**MUSGROVE
ENGINEERING, P.A.**

Re: **Renovate Infrastructure
Capitol Annex Phase 4
Department of Administration
Boise, Idaho
DPW Project No. 14006**

Addendum No. 1

BASEMENT TELECOM PLAN

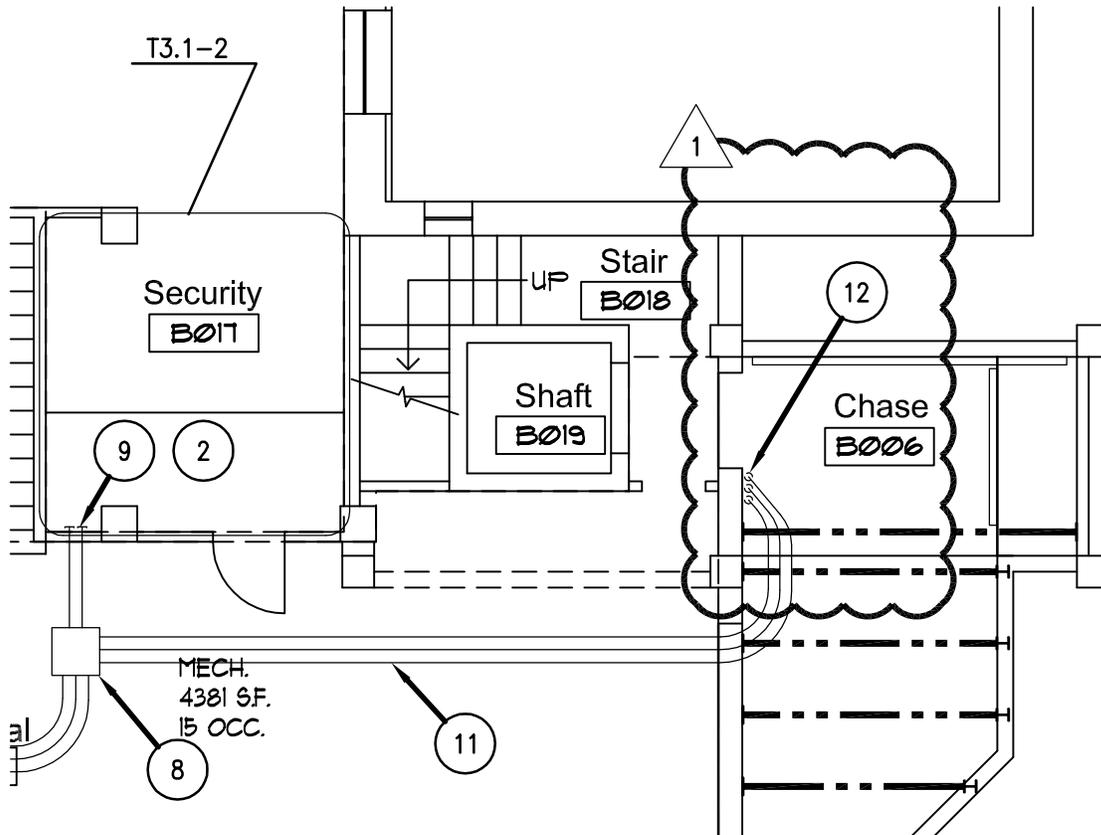
1. Revise location of conduits through ceiling of CHASE B006 to reflect correct location within future telecommunications room on floor above. See attached sketch.

FIRST FLOOR TELECOM PLAN

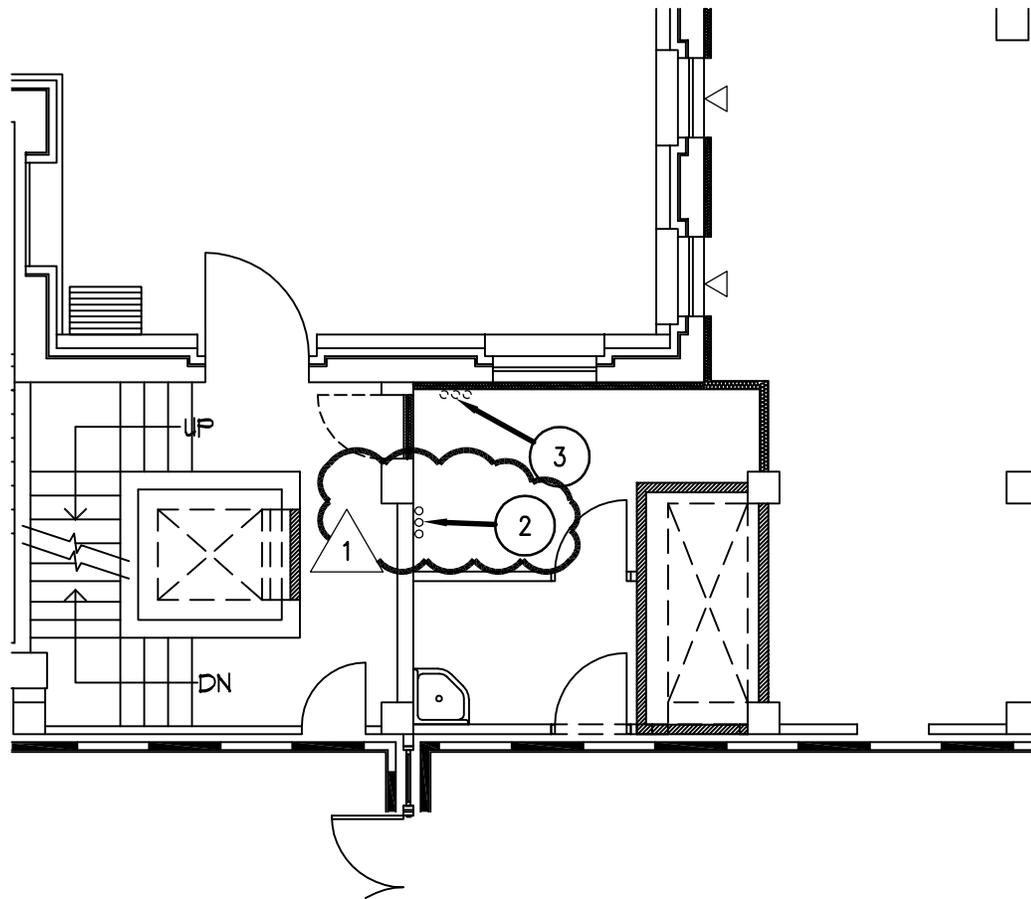
1. Revise location of conduits through floor and ceiling of future telecom room. See attached sketch.

ADD-1-1
Partial Basement Floor Plan
 Scale: $\frac{1}{4}'' = 1'-0''$

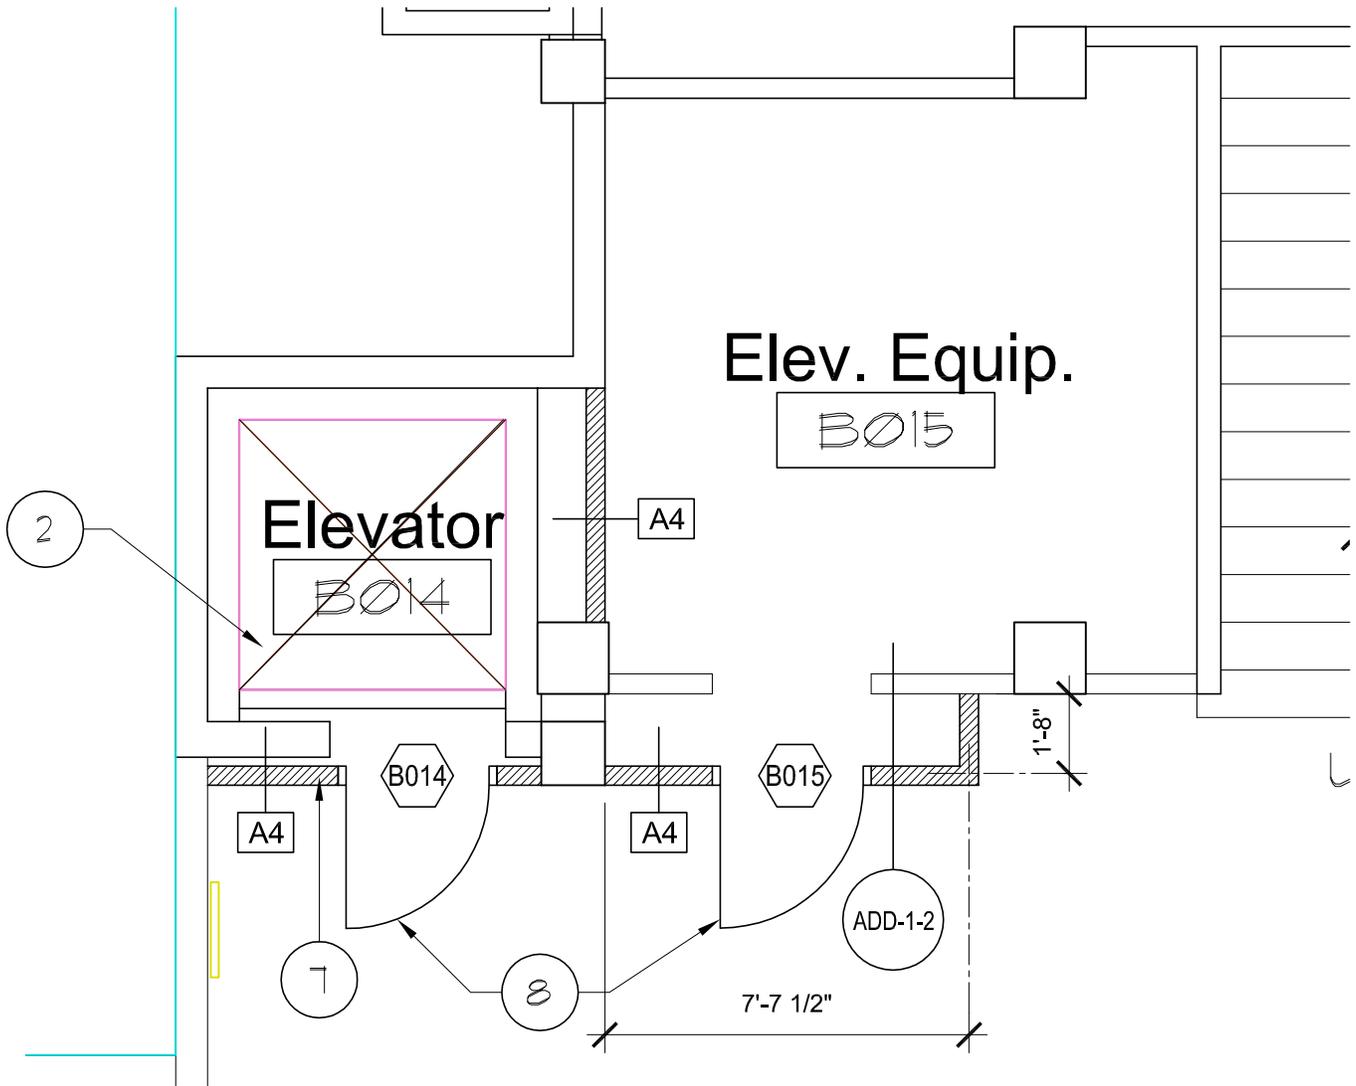
1. At basement level floor plan, provide wall and door details at Elevator B014 and Elevator Equipment B015 per Drawings ADD-1-1, and ADD-1-2, attached to this Addendum. Work shall be part of Alternate No. 1.

ADD-1-3

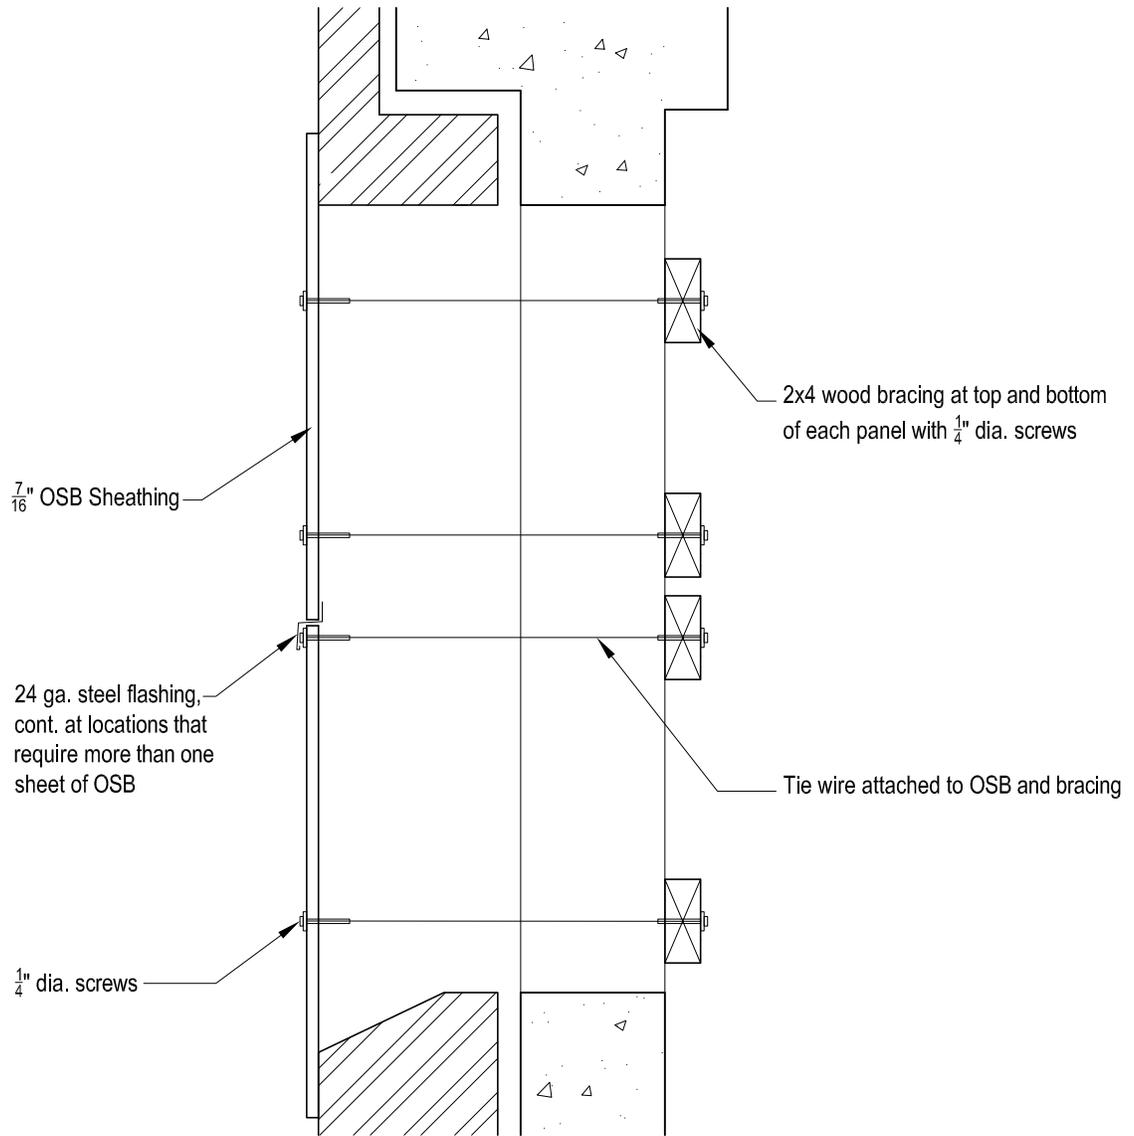
1. At North elevation on fourth level of east side revise (4) windows from 'S' designation to 'N' designation. Refer to Drawing ADD-1-3, attached to this Addendum.

BASEMENT LIGHTING PLAN

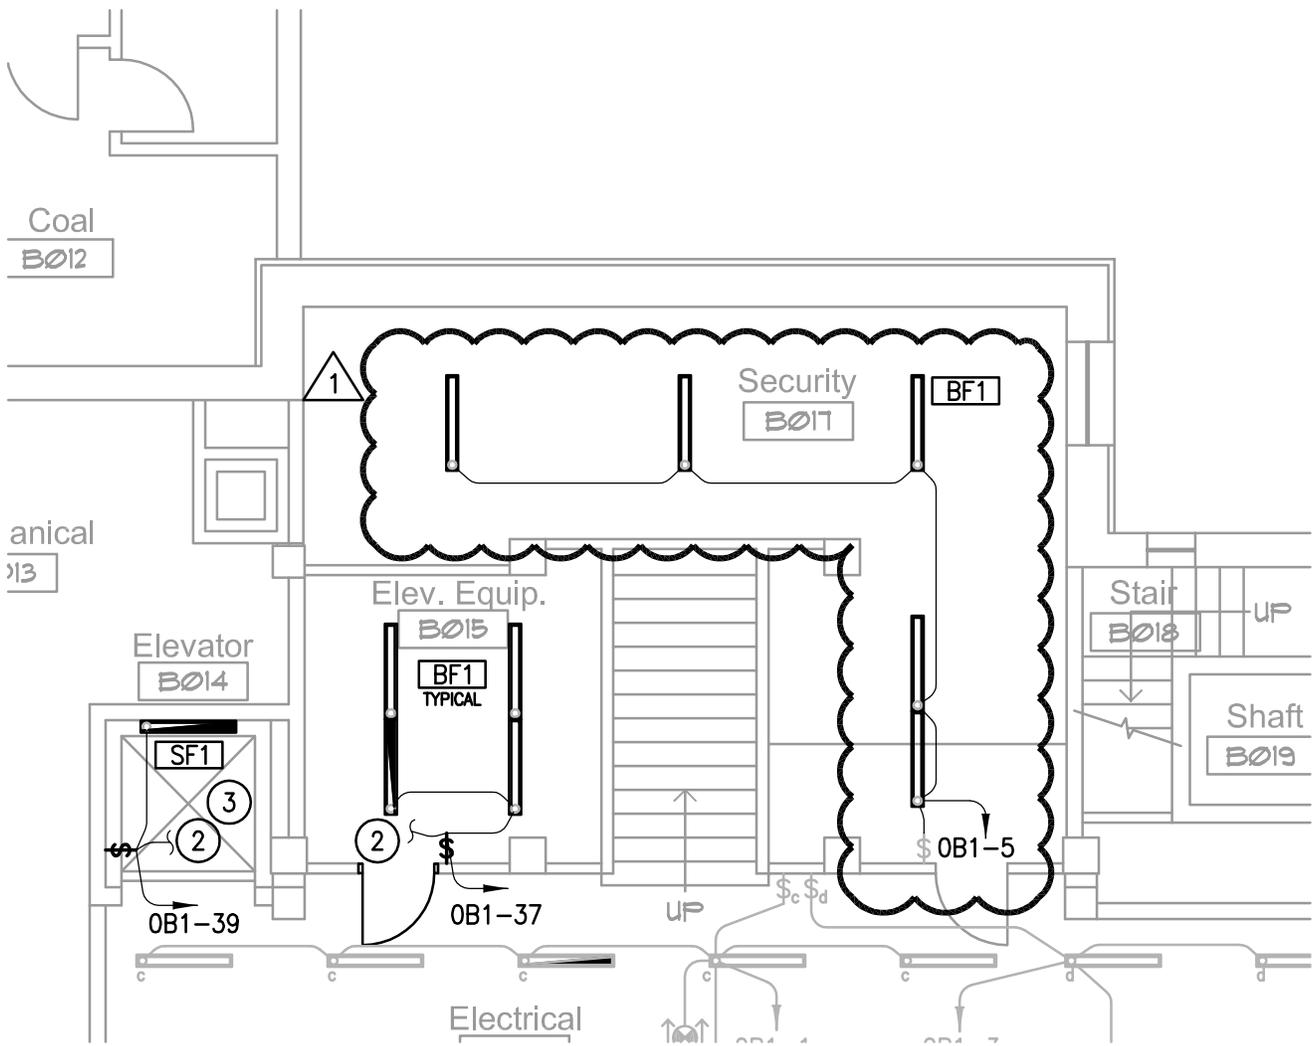
1. ADD lighting to Room B017.
2. REVISE Sheet Note No. 1.

1. EXISTING EXTERIOR & COMMON AREA LIGHTING CONTROL PANEL 'LCP'. FURNISH AND INSTALL 1" CONDUITS FROM 'LCP' UP INTO ELECTRICAL ROOM FOR CONNECTIONS TO EXTERIOR LIGHTING AND COMMON AREA LIGHTING IN CORRIDORS AND STAIRWAYS.

THIRD FLOOR POWER PLAN

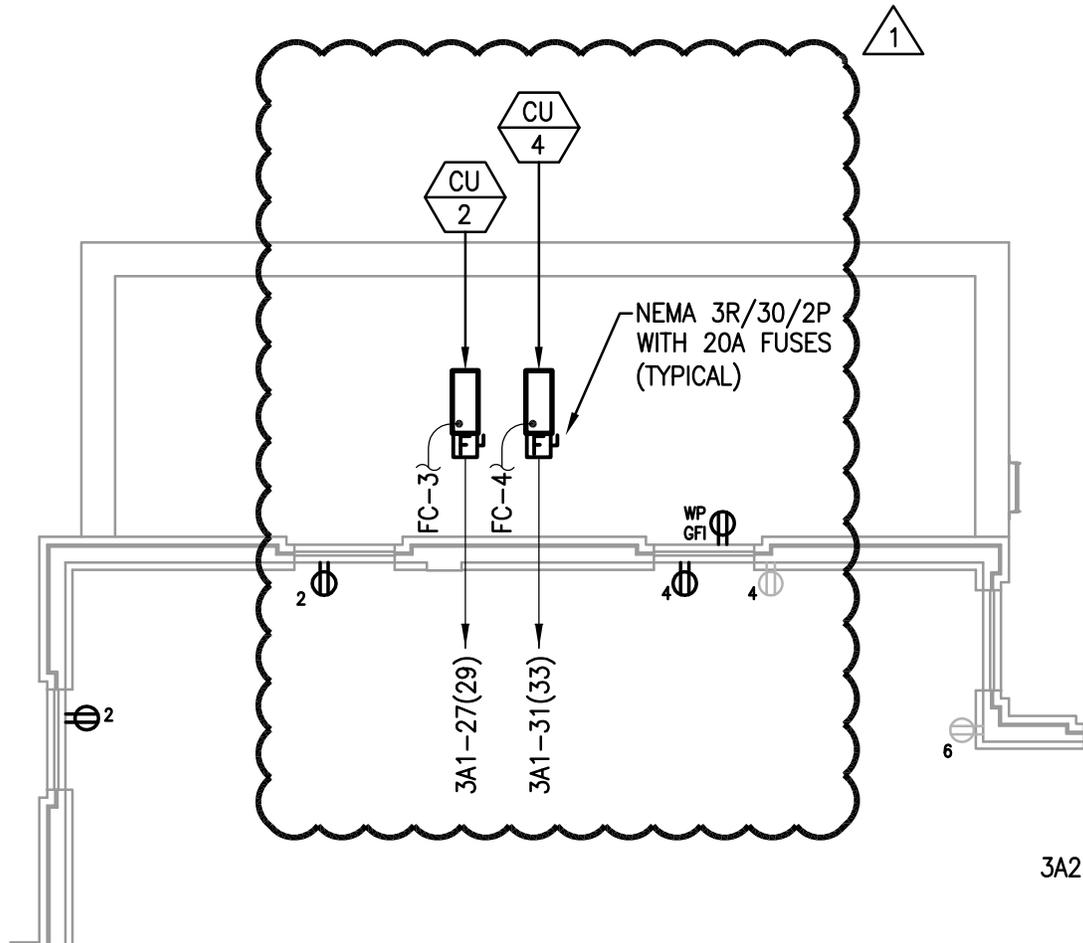
1. RELOCATE electrical requirements for CU-1 and CU-3 to Fourth Floor Power Plan.
2. REVISE locations CU-2.
3. DELETE electrical requirements for CU-5 and CU-6.
4. REVISE layer for disconnects to indicate new (as indicated in note adjacent disconnects).

FOURTH FLOOR POWER PLAN

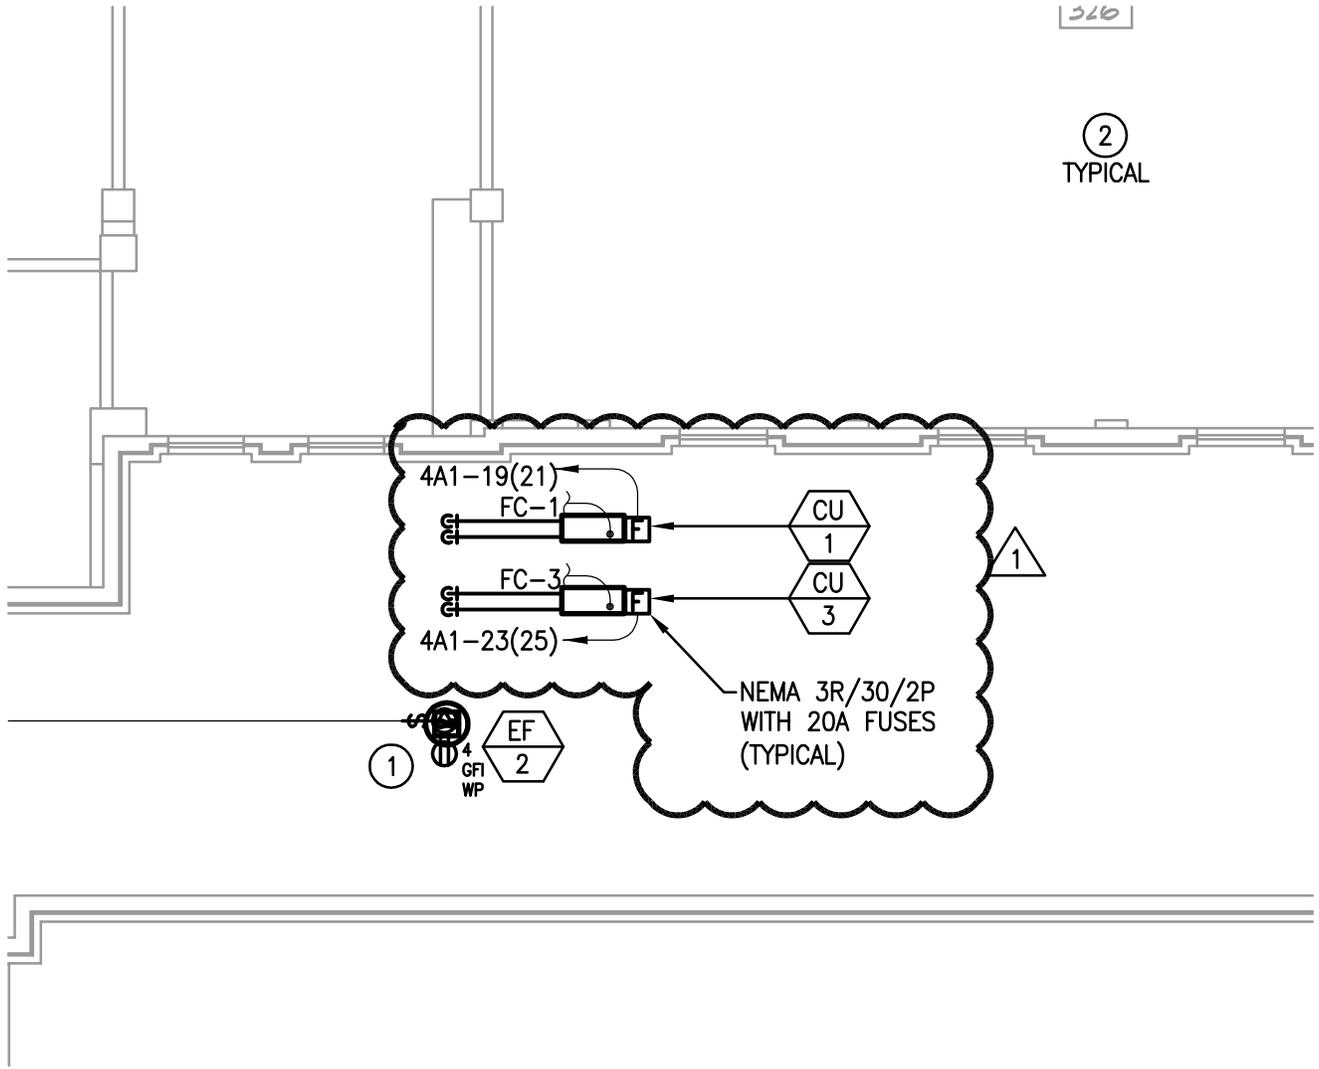
1. ADD electrical requirements for CU-1 AND CU-3 for relocated equipment.

1 SINGLE LINE DIAGRAM

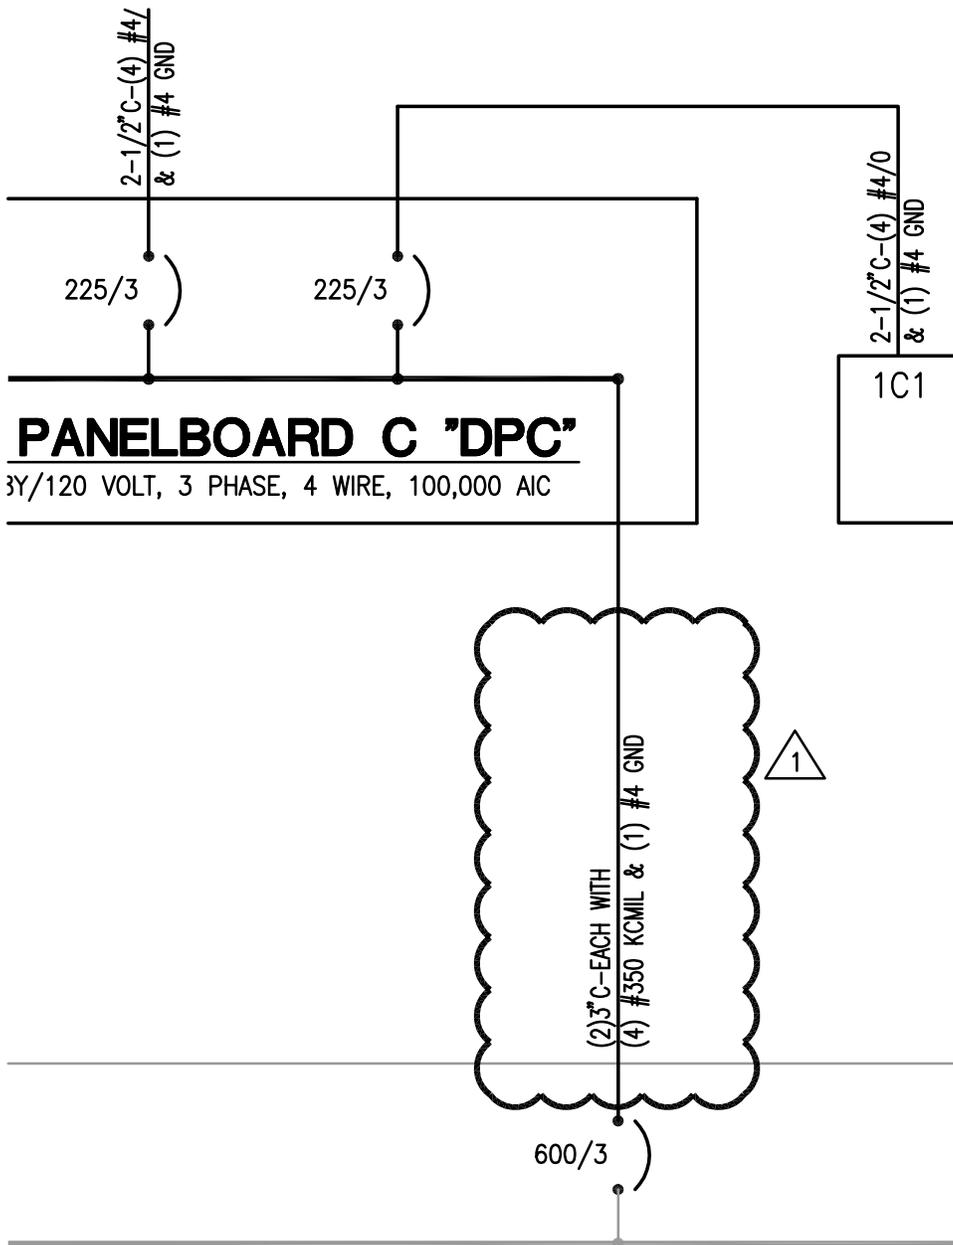
1. ADD feeder requirement for Distribution Panelboard C 'DPC'.
